Appendix 3: BRIDGE SUMMARY- MAZENGARB BRIDGE
Site Specific Management Plan 004 - [Sectors 420]
MacKays to Peka Peka Expressway

01 SEPTEMBER 2014 - CERTIFIED ISSUE - REV C

AEE Consented to DET Proposed Graphic Comparison

PROPOSED PLAN- MAZENGARB ROAD BRIDGE - 1:500@A3

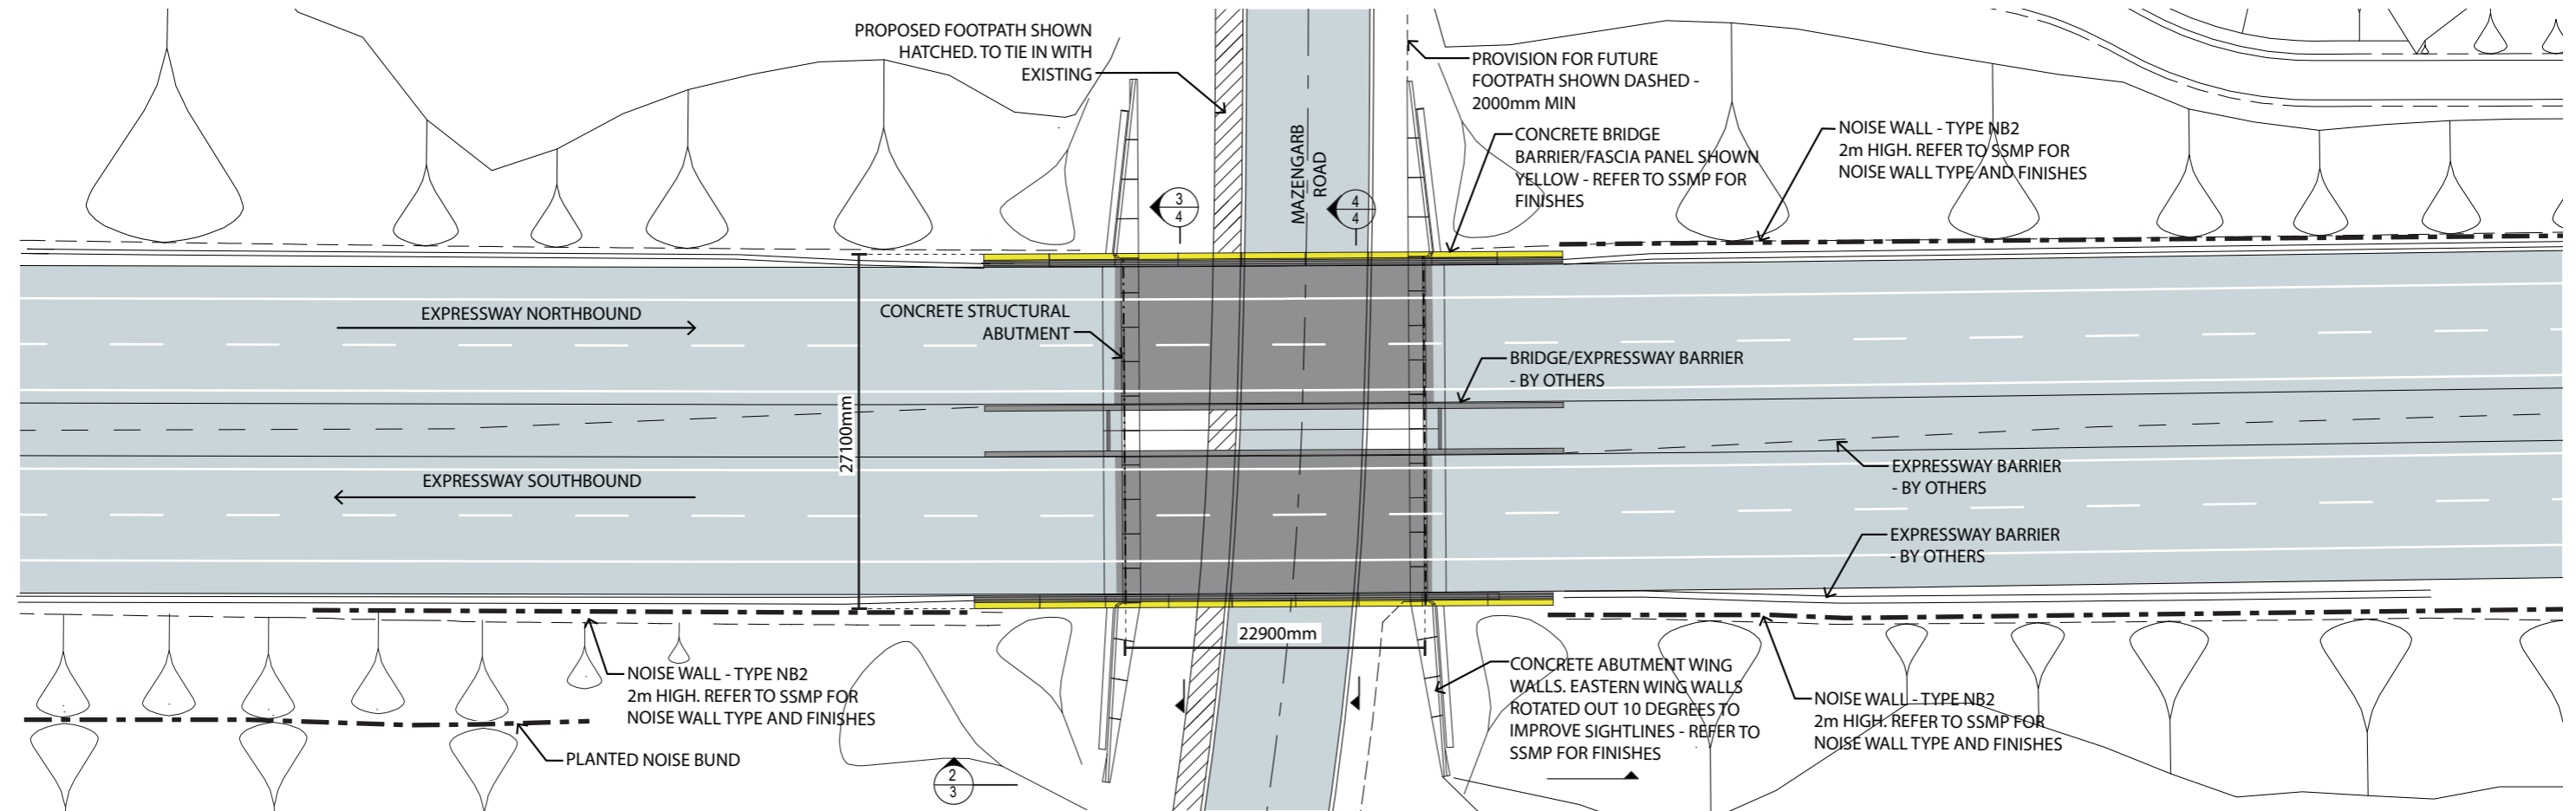
1. Reduced bridge skew. From 3° to 0°
2. More detail provided for abutment treatment
3. Extent of noise walls shown
4. No footpath constructed on the northern side of Mazengarb Road

| <ol style="list-style-type: none"> 1. Improves constructibility 2. Lack of abutment information in AEE phase. The bridge abutments tie in with and retain the proposed embankments. The abutment wing walls are designed as one long continuous element, they lead pedestrians though and under the bridge | <ol style="list-style-type: none"> 3. connecting one side to the other. 3. Provided for reference only. Refer to SSMP for more detail and finishes 4. No existing footpath to tie in to on the northern side. Space provision for future footpath. |

2. PROPOSED ELEVATION - MAZENGARB ROAD BRIDGE EAST ELEVATION - 1:250@A3

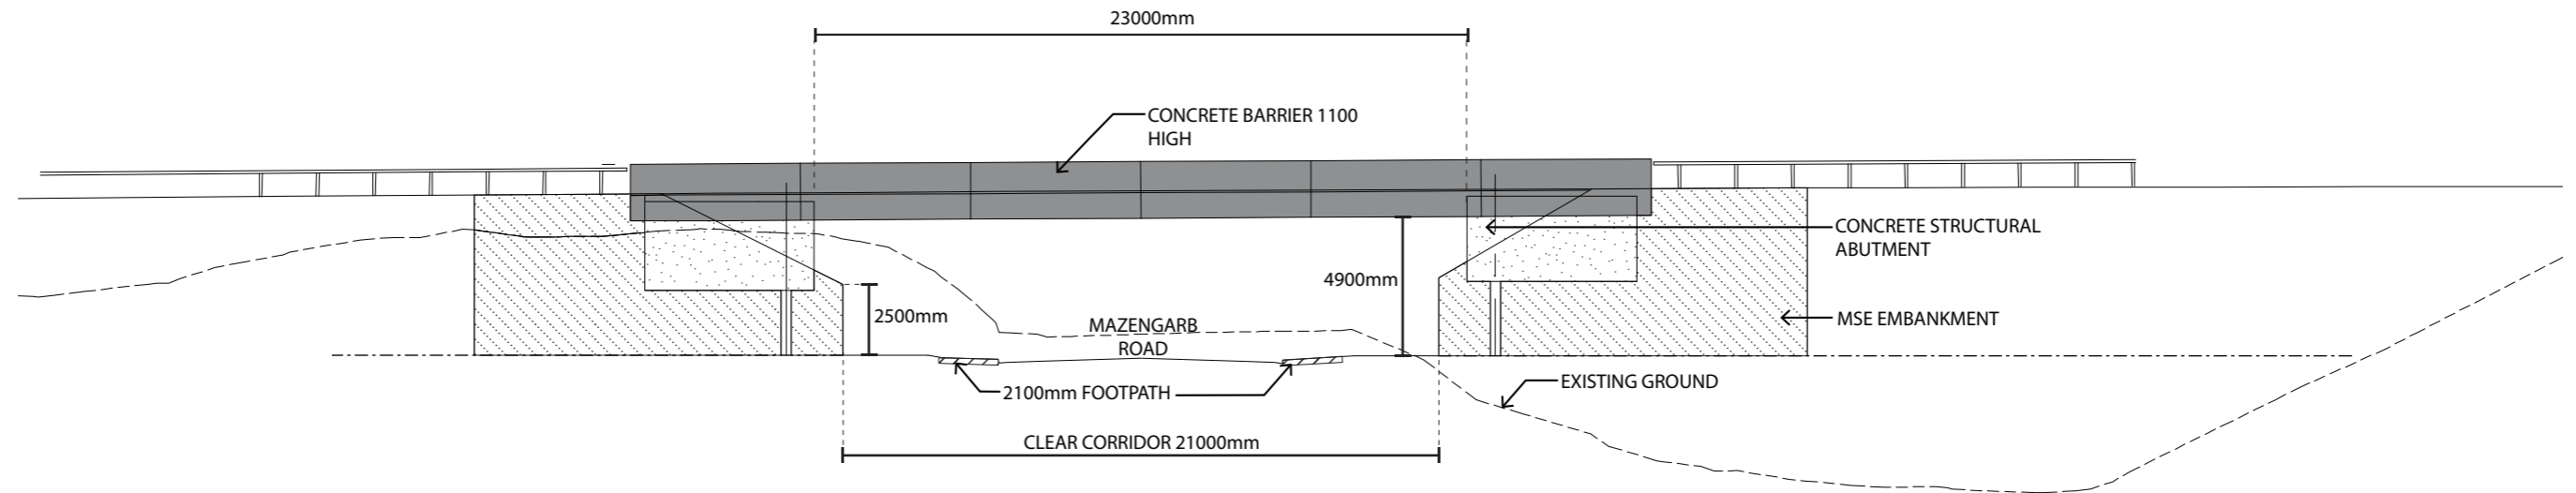
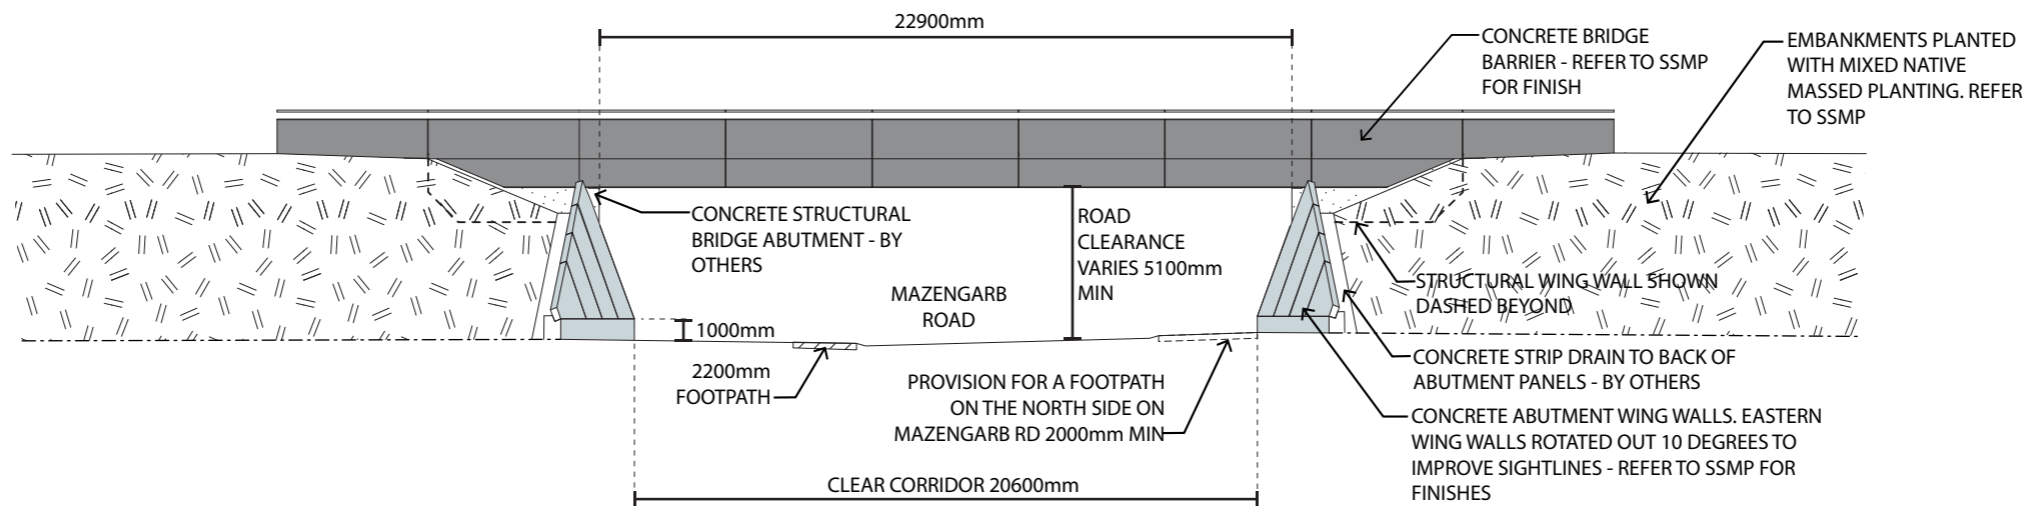
1. More detail provided for abutment treatment
2. No footpath constructed on the northern side of Mazengarb Road

1. Lack of abutment information in AEE phase. The bridge abutments tie in with and retain the proposed embankments. The abutment wing walls are designed as one long continuous element, they lead pedestrians though and under the bridge
2. connecting one side to the other.
No existing footpath to tie in to on the northern side. Space provision for future footpath.

4. PROPOSED SECTIONAL ELEVATION - MAZENGARB ROAD BRIDGE (LOOKING NORTH) - 1:200@A3

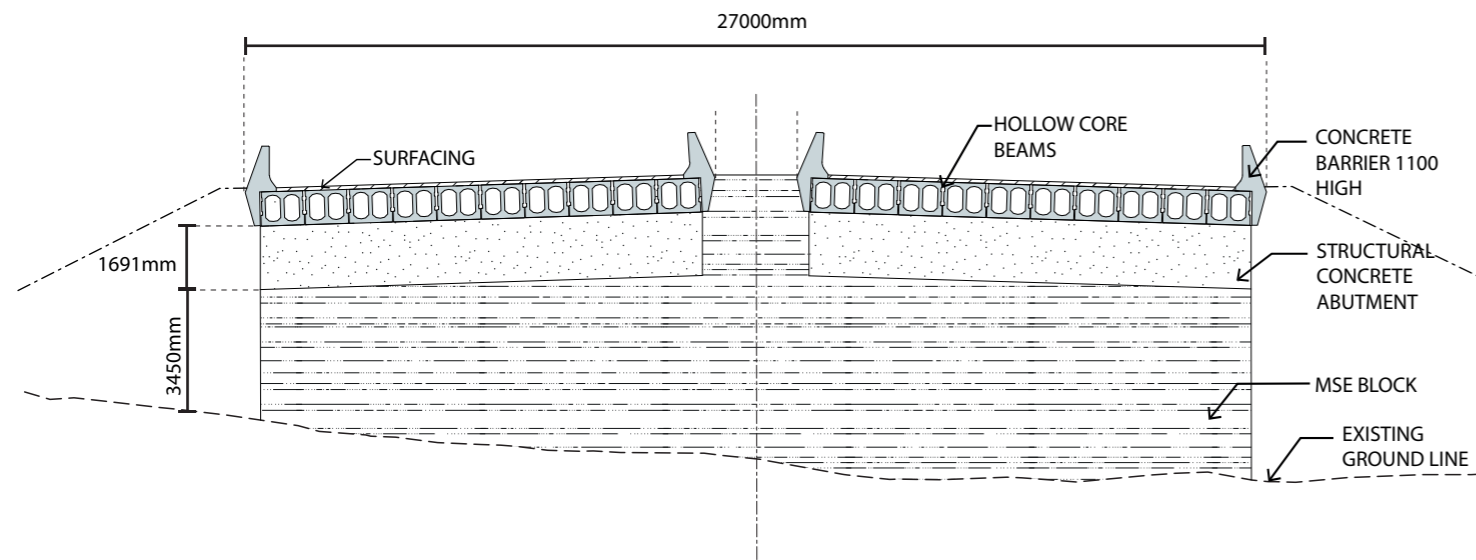
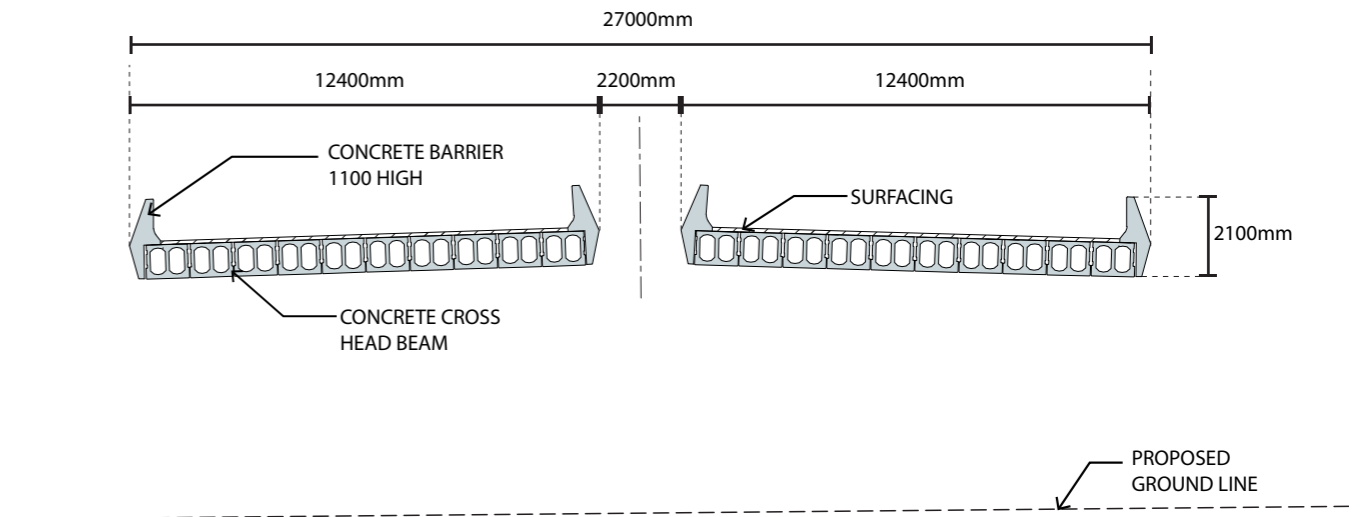
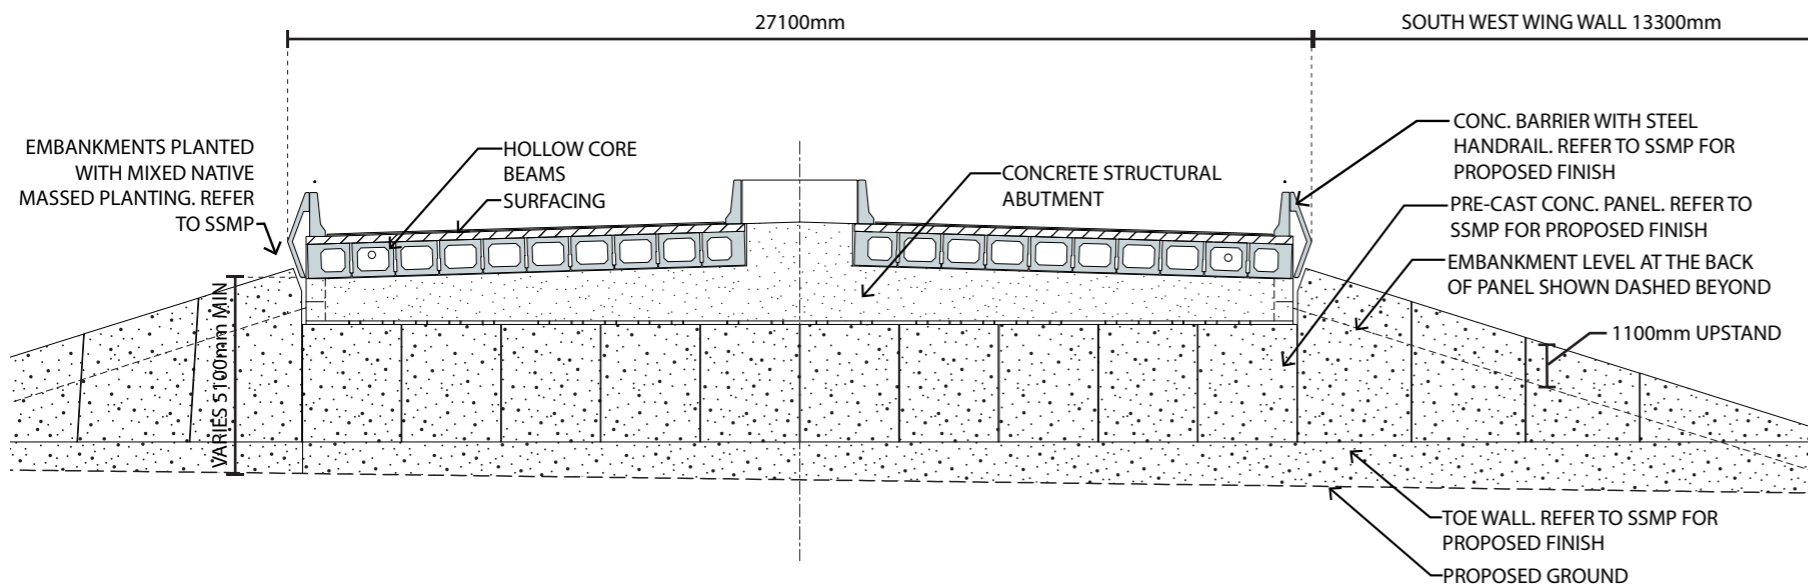
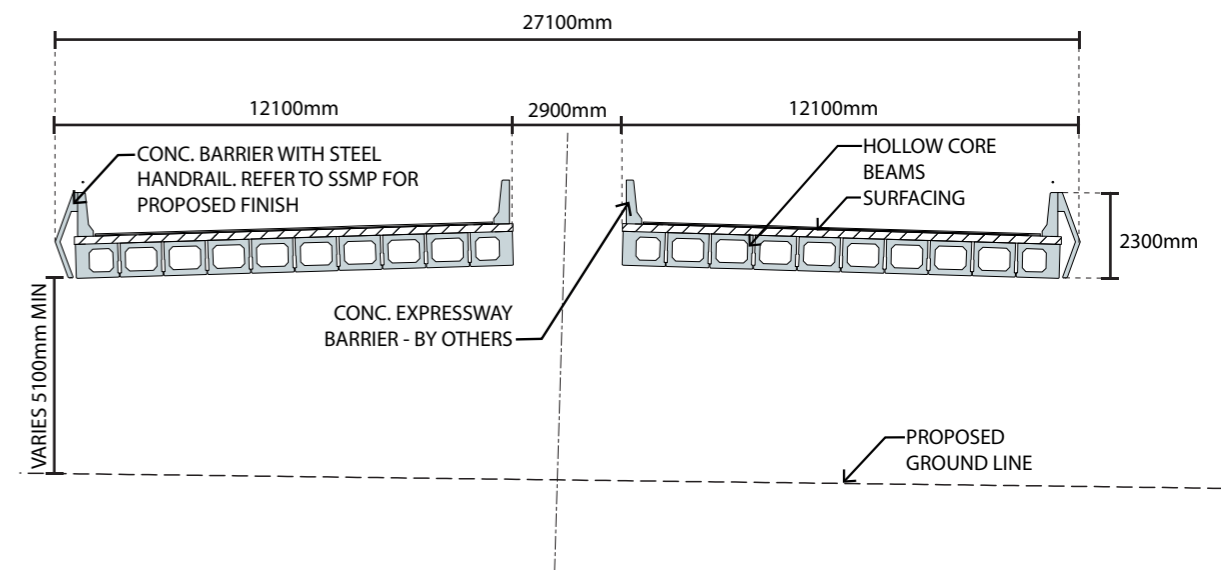
1. More information provided for the bridge abutment
2. Bridge concrete fascia panels removed from the inside of the bridge

1. Lack of abutment information in AEE phase. The bridge abutments tie in with and retain the proposed embankments. The abutment wing walls are designed as one long continuous element, they lead pedestrians through and under the bridge

2. connecting one side to the other.
2. Increase width of light shaft.

Abutment Elevation 1:100@A3

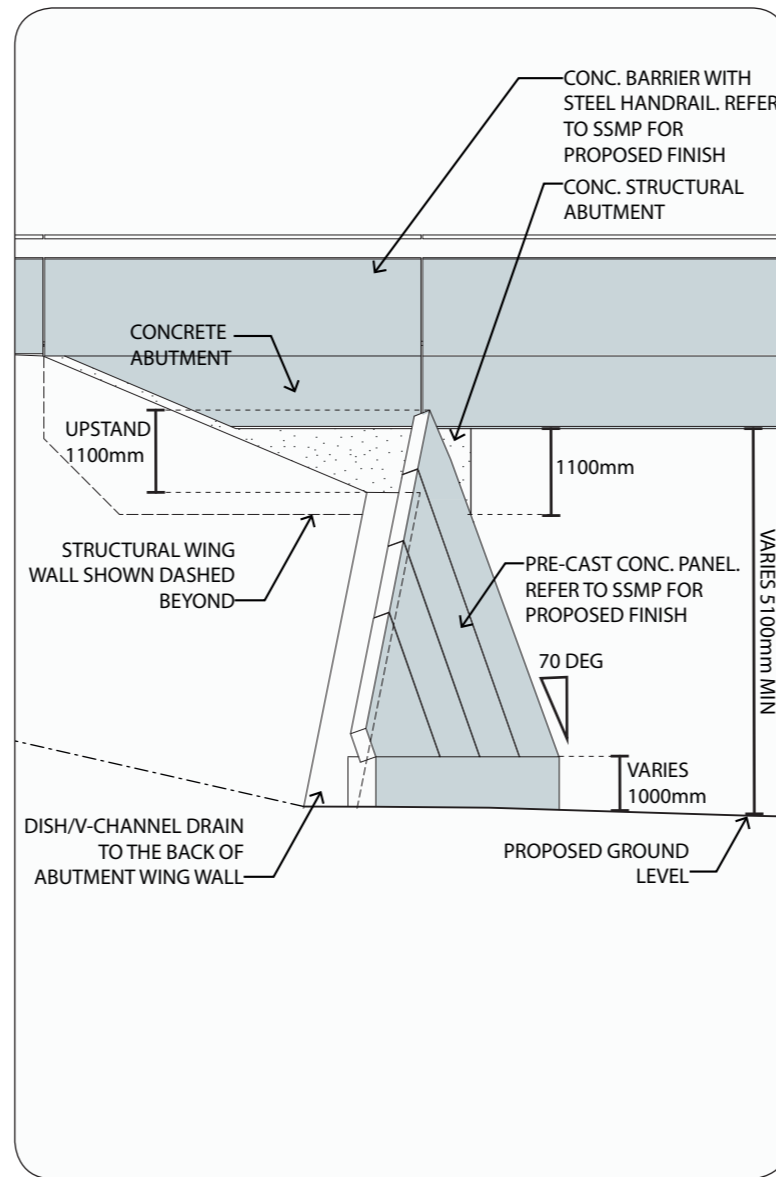
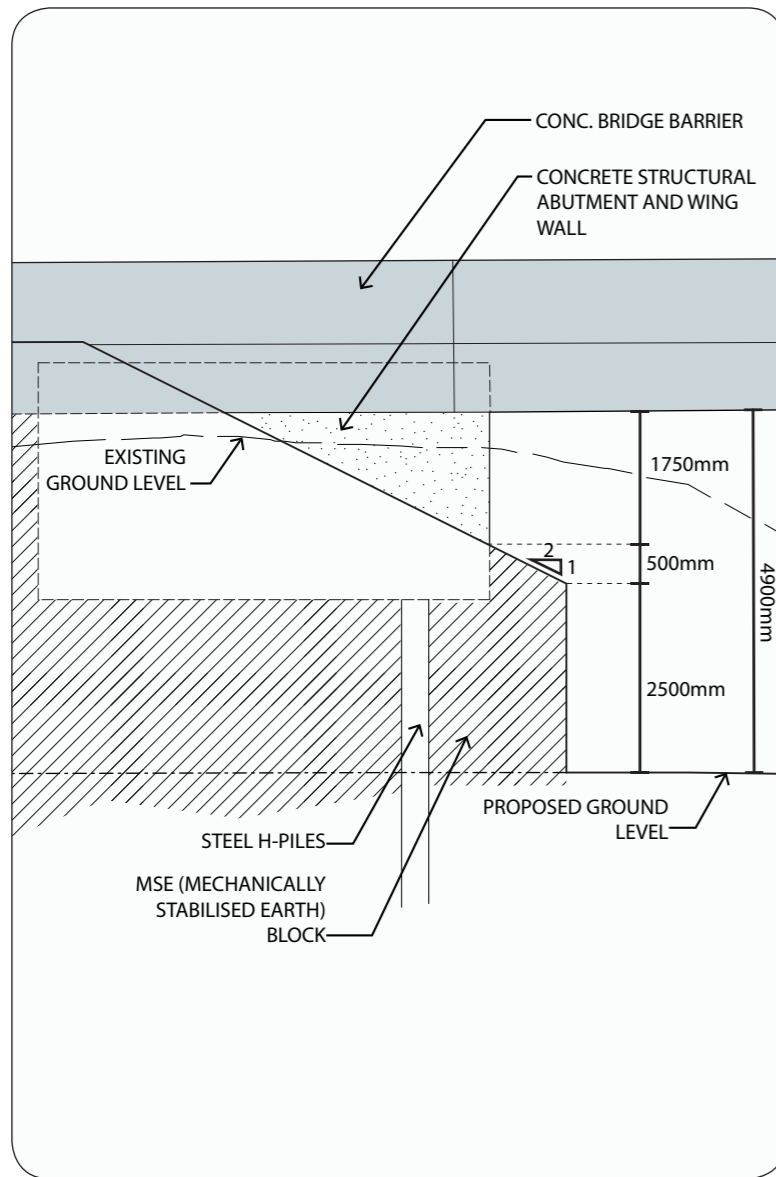
1. More information provided for the bridge abutment
2. Spill through abutment angel reduced.
3. Handrail shown on top of barrier

1. Lack of abutment information in AEE phase. The bridge abutments tie in with and retain the proposed embankments. The abutment wing walls are designed as one long continuous element, they lead pedestrians though and under the bridge connecting one side to the other.
2. To be consistent with the proposed Otaihang Road bridge, improve sightlines.
3. Missing from AEE. Safety requirement for cyclists using the expressway

Cross Head & barrier junction 1:100@A3

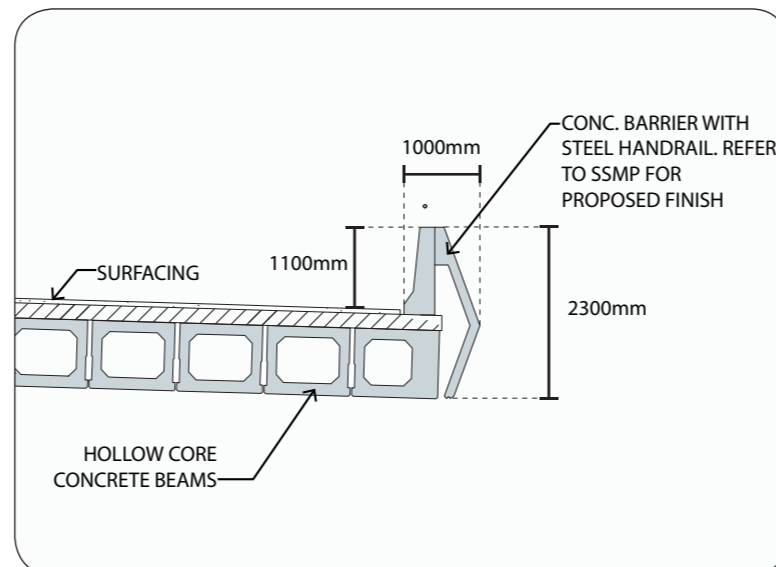
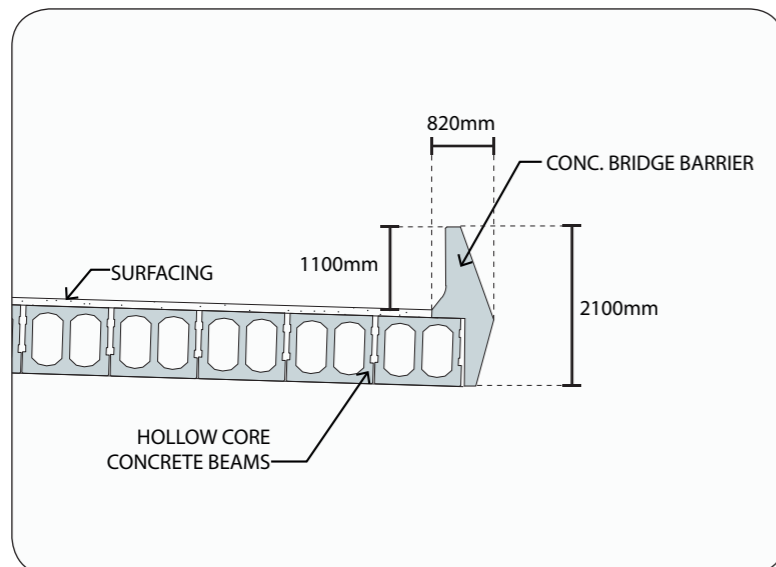
1. Handrail shown on top of barrier
2. Bridge fascia panel height increased

1. Missing from AEE. Safety requirement for cyclists using the expressway.
2. Increase to the bridge deck depth.
